**ADDENDUM NO. 1
TO
PLANS AND SPECIFICATIONS
FOR
PROJECT NO. ENG200372291**

DESCRIPTION OF PROJECT: Double Vault Toilet Installation Improvements 2021

LOCATION: Brown County State Park

INDIANA STATE AGENCY: DEPARTMENT OF NATURAL RESOURCES

VAULT TOILET
 Department of Natural Resources

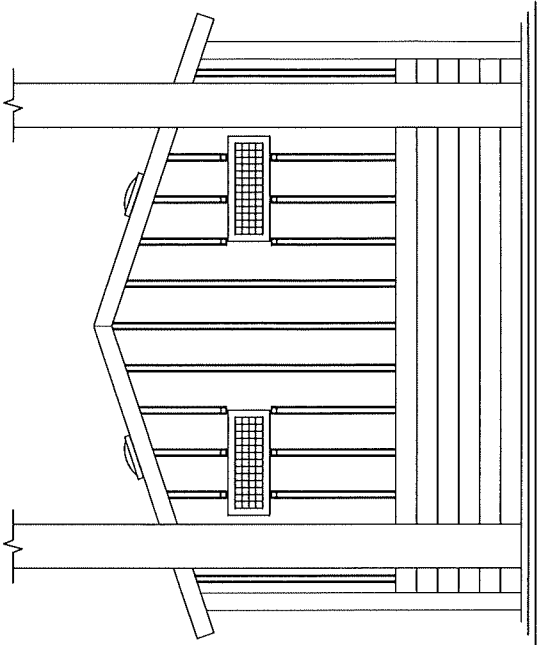
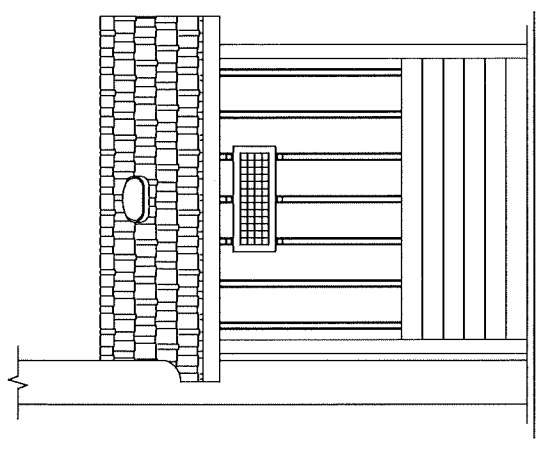
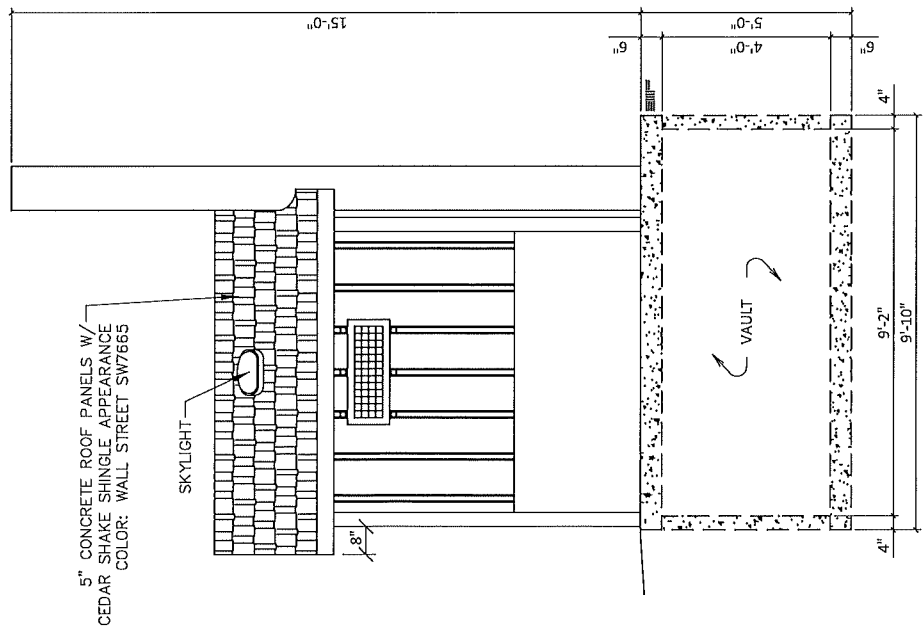
Add: See elevation and floorplan double vault toilet sheets for your information. The vault weight is 12,000 lbs. and the building weight is 30,000 lbs.

Accessible Parking

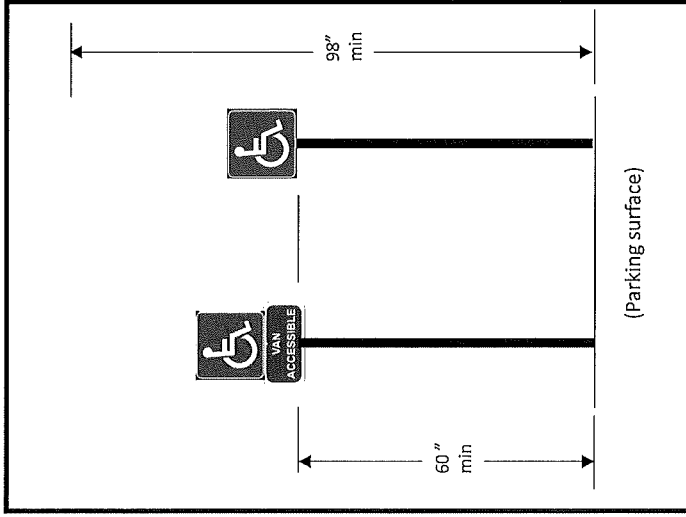
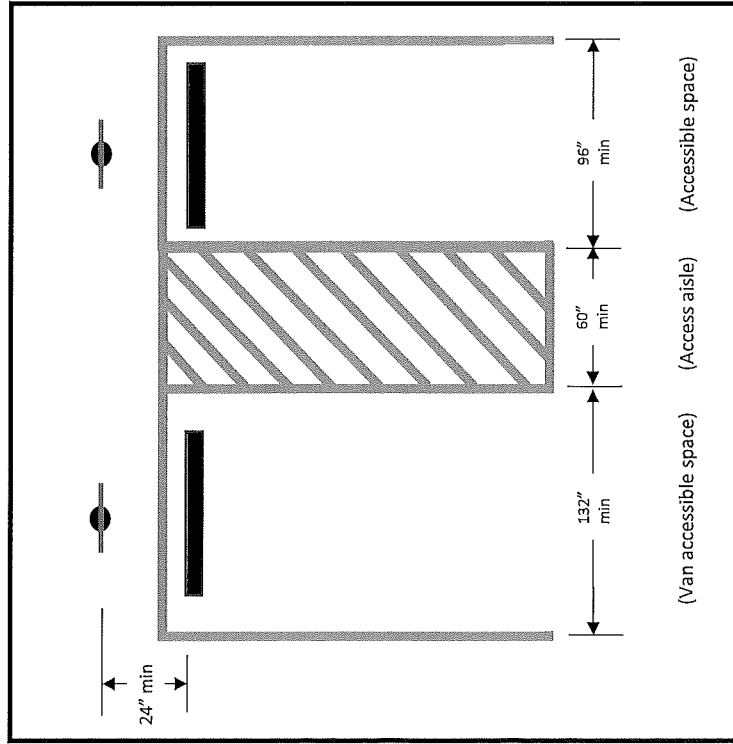
Clarification: Where applicable, contractors shall provide accessible parking per the attached detail sheet.

Strahl Lake
Site # 1

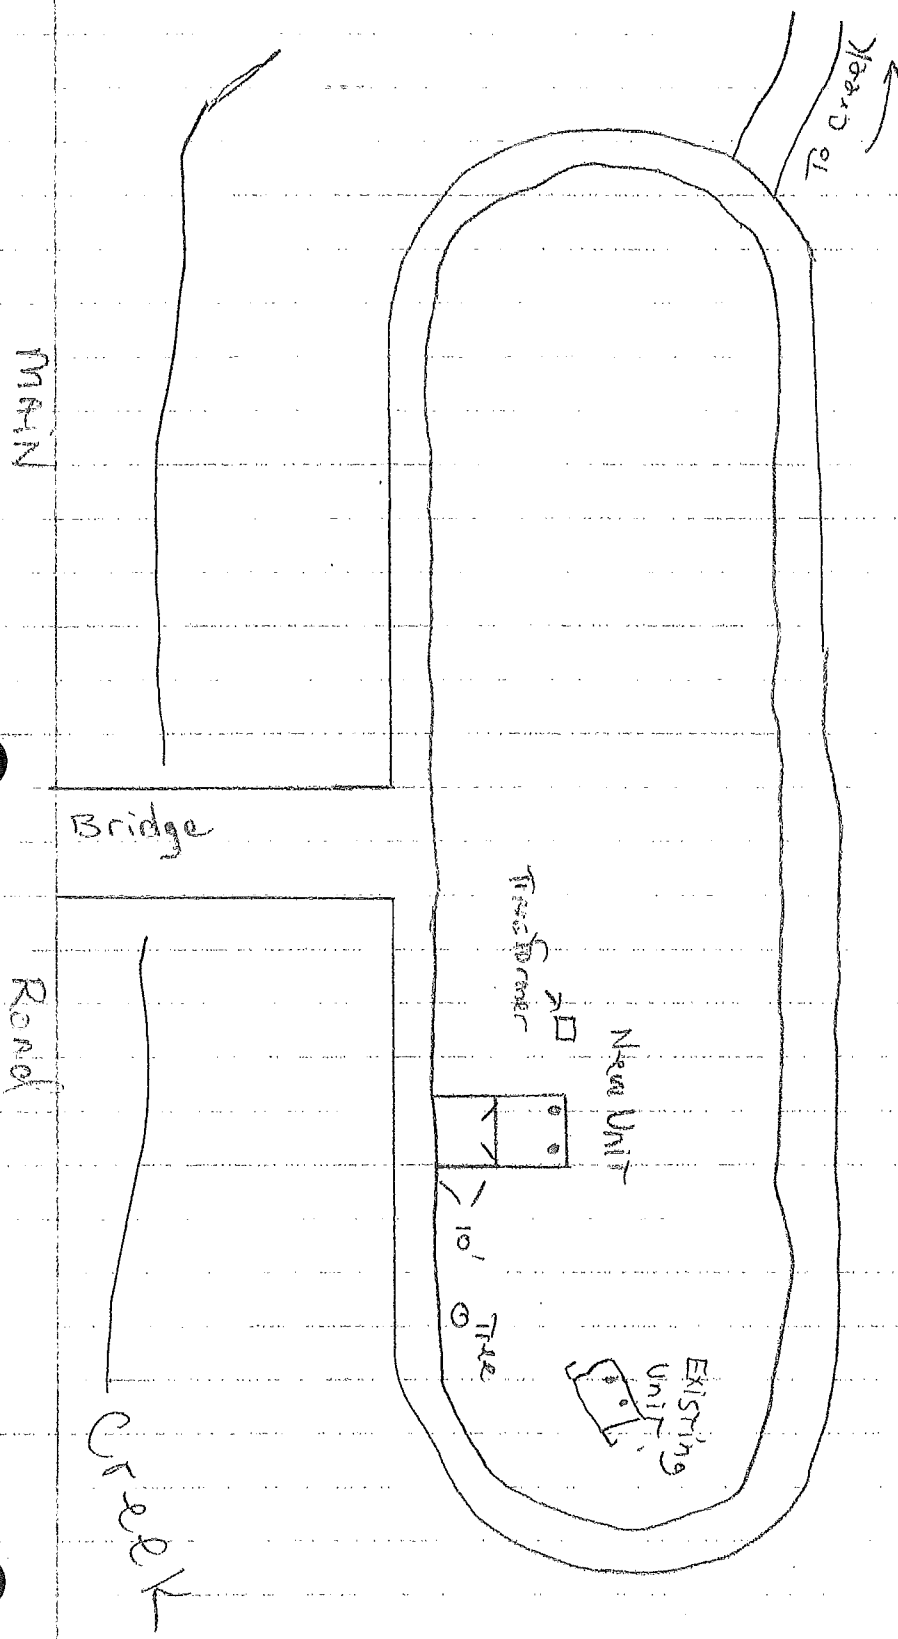
- Grass seed in this area.
- sign on bollard post.
- vault finished floor 3" above asphalt & of parking.
- Parking block.
- concrete approach to meet ADA slope % guidelines.

Remove existing vault across road by contractor.

Site #3 - Horse Camp #2

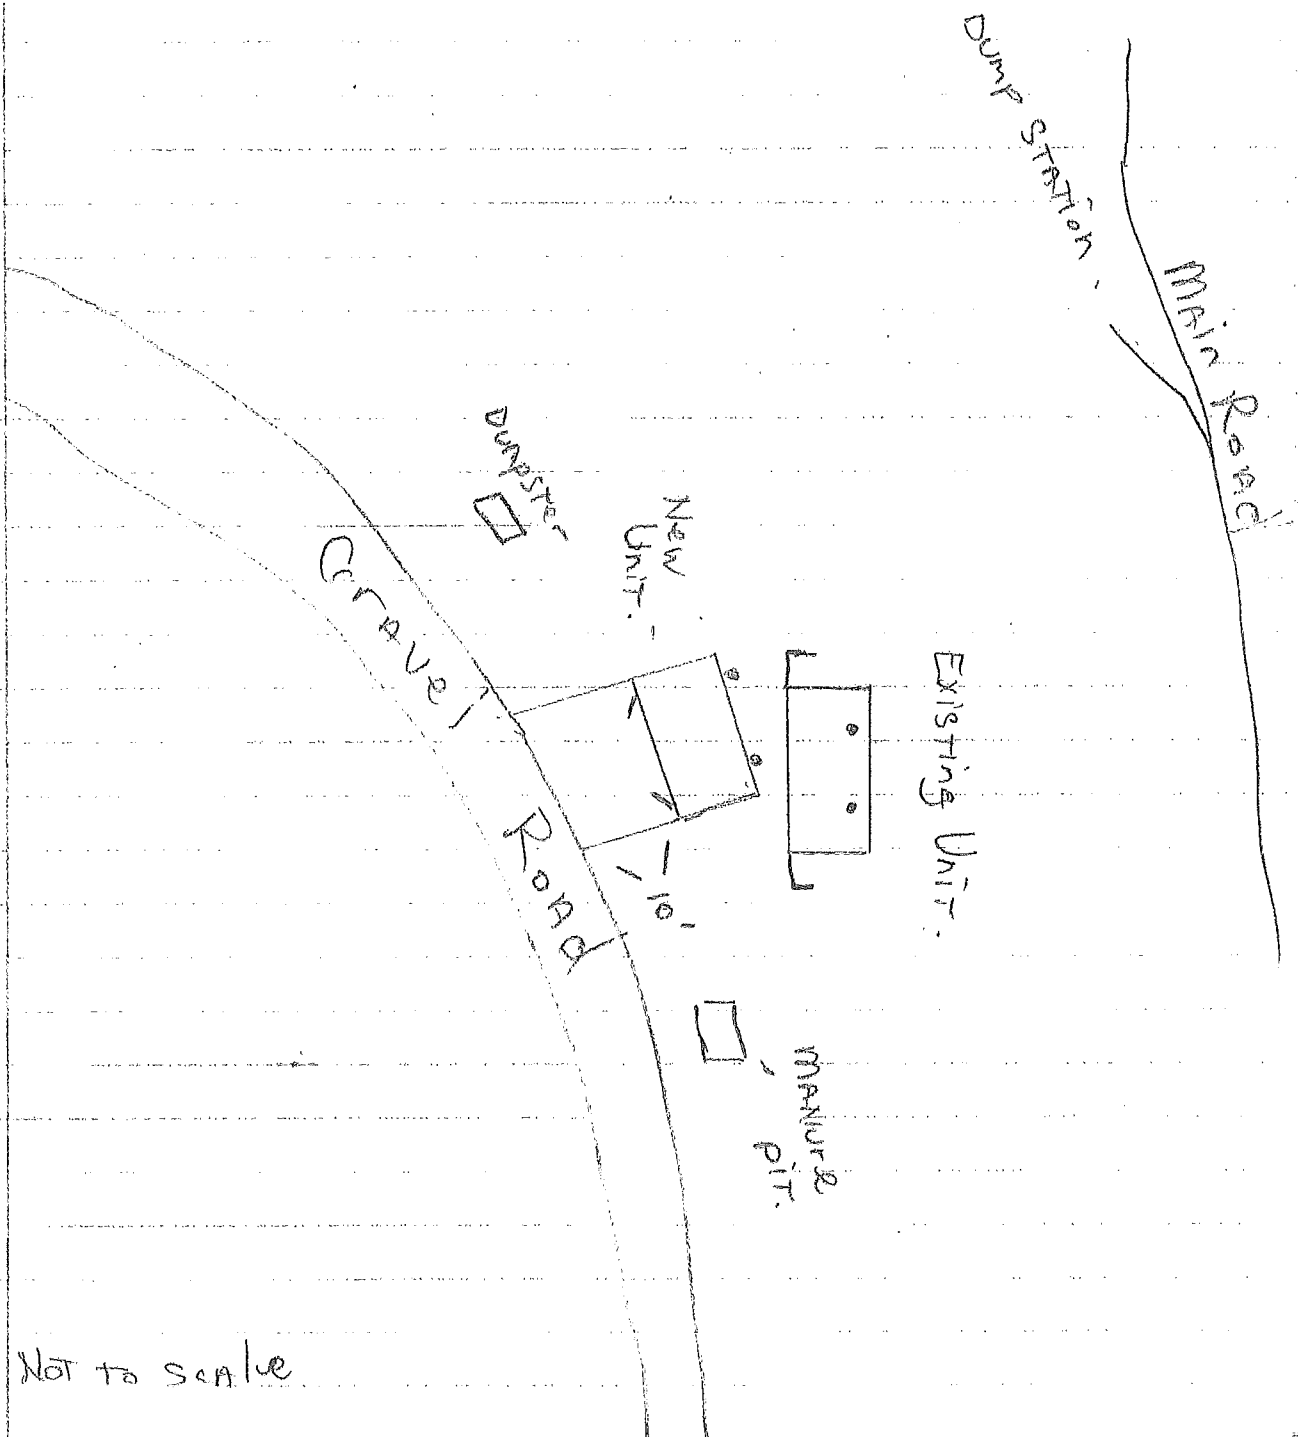
- New unit in front of old unit.
- Seed finish grade
- Demo old unit.
- Finish floor 3" above gravel surface - front &
- Concrete approach to meet ADA slope % guidelines.

Site #4 - Kelp Playground

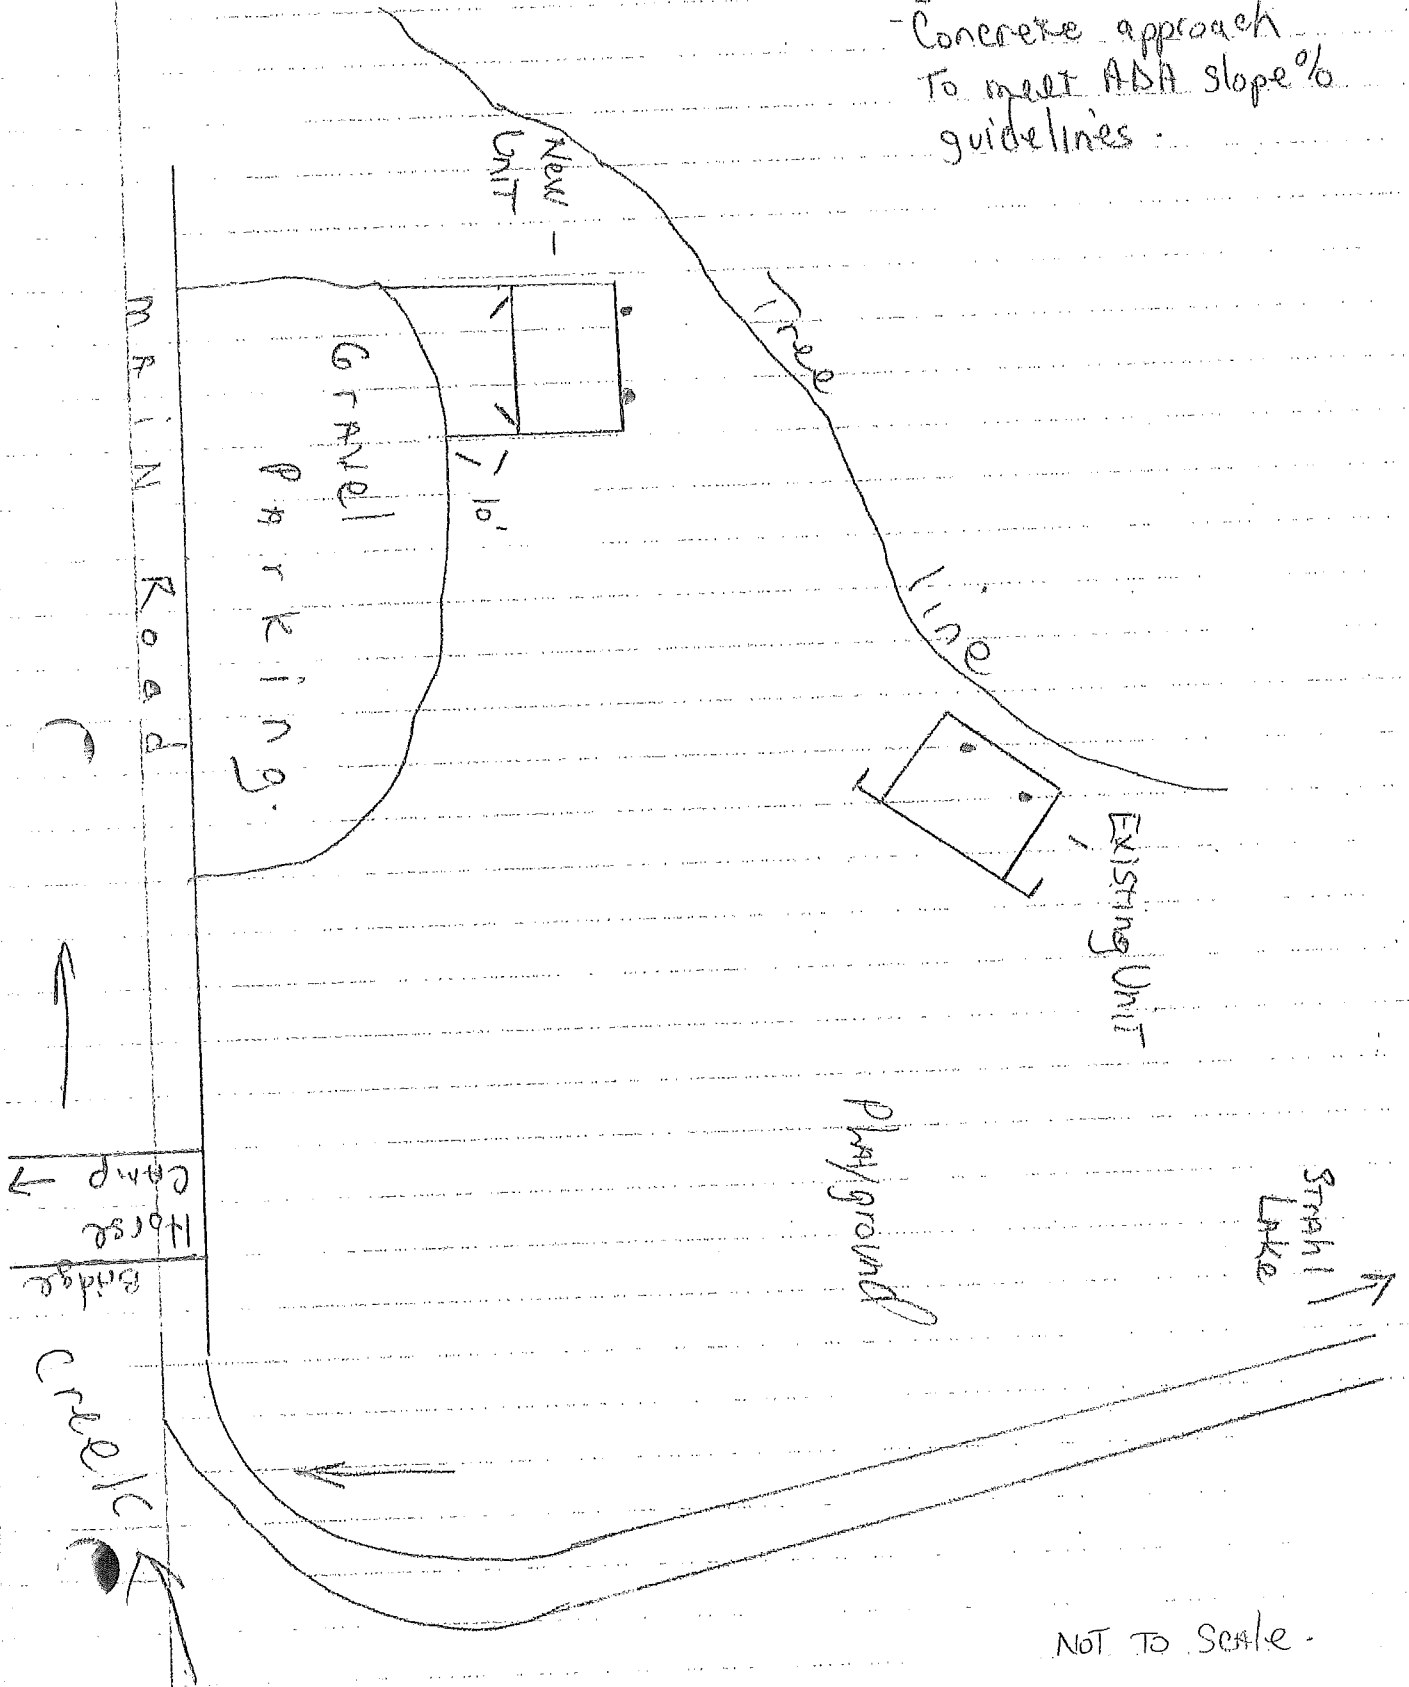
- Demolish old unit.
- Seed finish grade
- Finish Floor 3" above gravel surface - front f.
- Concrete approach To meet ADA slope% guidelines.

Site # 5 - CCC Shelter

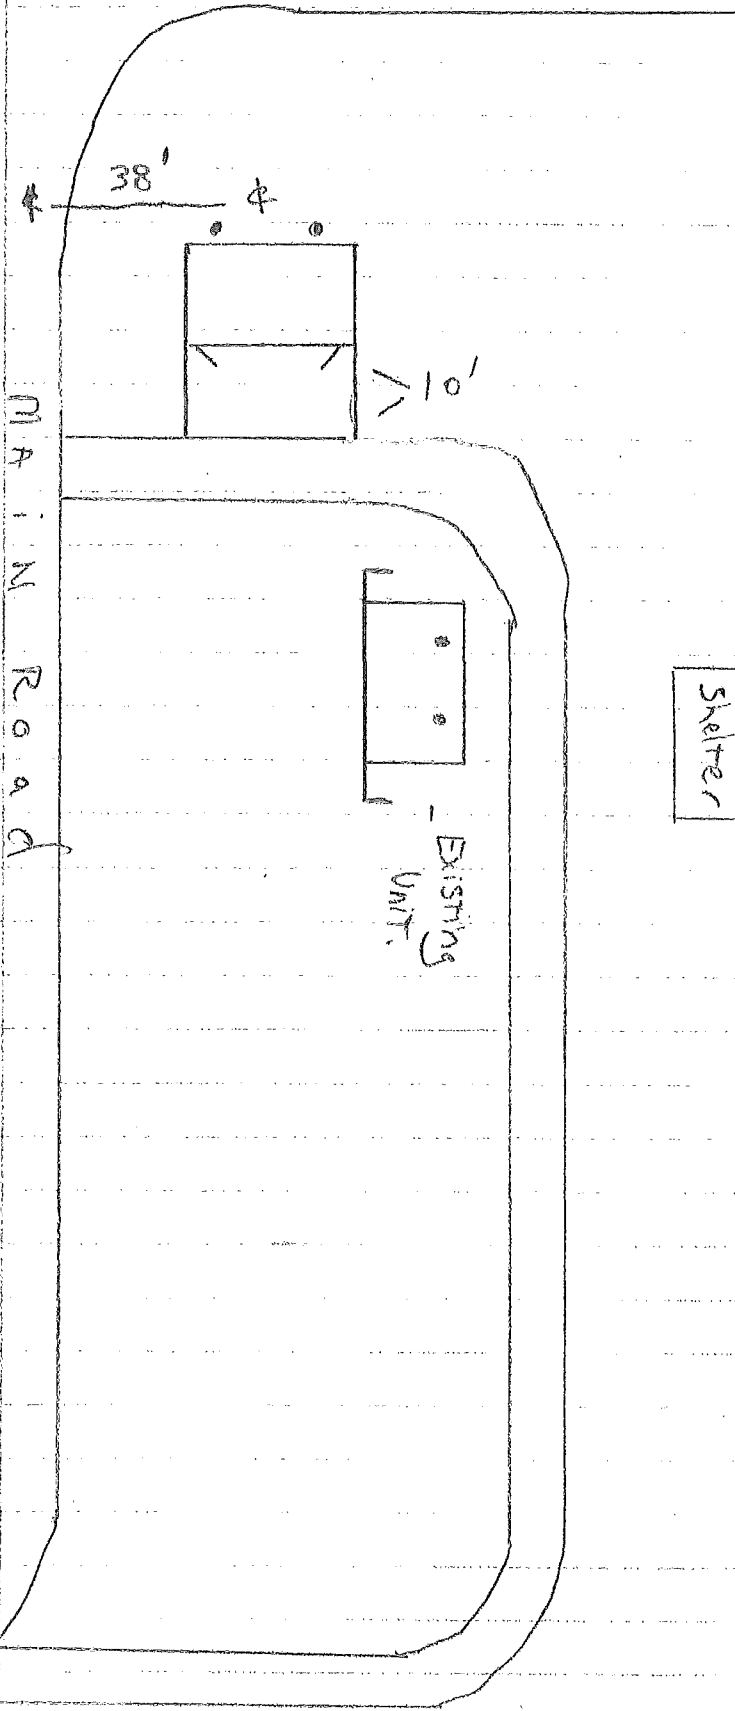
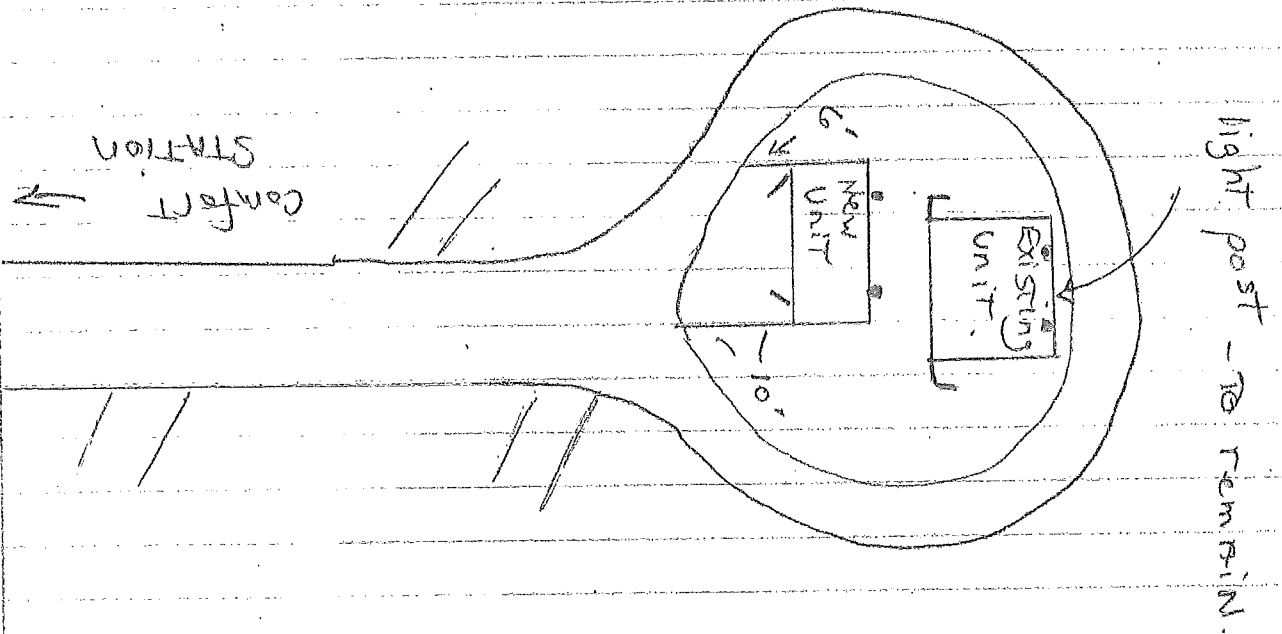
- Demo old unit
- Seed finish grade
- Finish floor 3" above gravel surface
- front ϕ .
- Concrete approach to meet ADA
- Slope % guidelines
- 38' off ϕ line of MAIN ROAD TO ϕ line of UNIT.

Site # 7 - Family Camp # 2

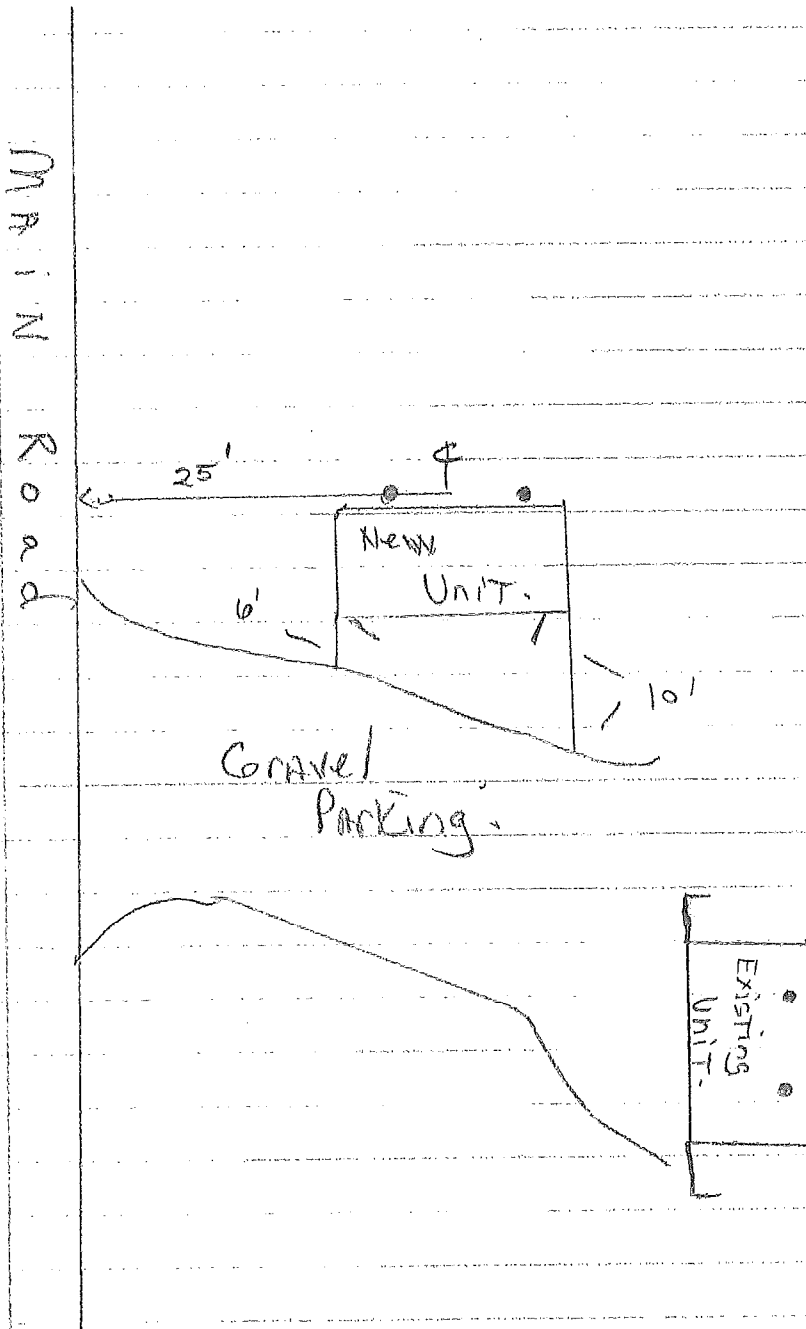
- Demo old unit.
- Muleh Finish Concrete
- Finish Floor, 3" above gravel surface
- 4 - front.

- Unit to set 25' off edge of main road asphalt. - to 4 of unit.
- Concrete approach To meet ADA slope % guidelines.
